Client:	Space Solutions (UK) Ltd
Project:	Kingsway Mews (127/143 Kingsway, London SW14 7HN)
Reference:	Fire Safety Advice Note for Planning Application

1. Introduction

Figure 3: Kingsway Mews – (Approx.) Distances with Dry Riser System

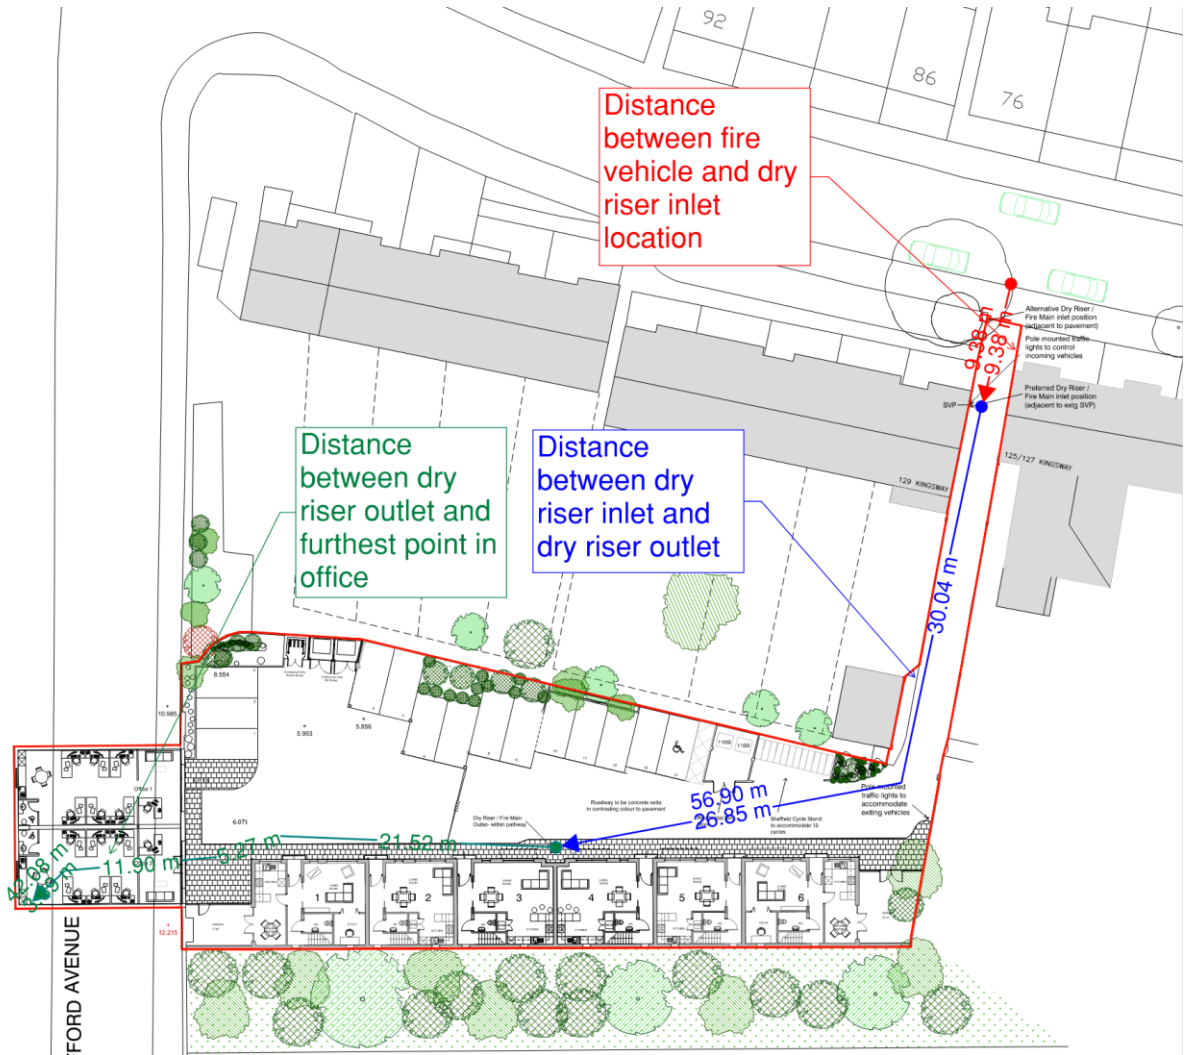
2.10 Another fire safety measure discussed with the team is the implementation of an external dry riser pipe system. The dry riser inlet should be located within 18m and visible from the fire vehicle arriving at Kingsway. The fire brigade can then use this dry riser system with an external outlet which should be located such that all areas within the dwellinghouses and the office area are covered by a 45m hose distance (. Both dry riser inlet and outlet should be located vertically.

2.12 Figure 3 below outlines the walking distance between dry riser inlet and outlet and fire hose distance from dry riser outlet to furthest point in this development.

2.11 Details of the dry riser system, exact inlet/outlet location, management and maintenance regime should be outlined in detail during the next stage and presented to the Local Fire Brigade as part of the Building Regulations application process.
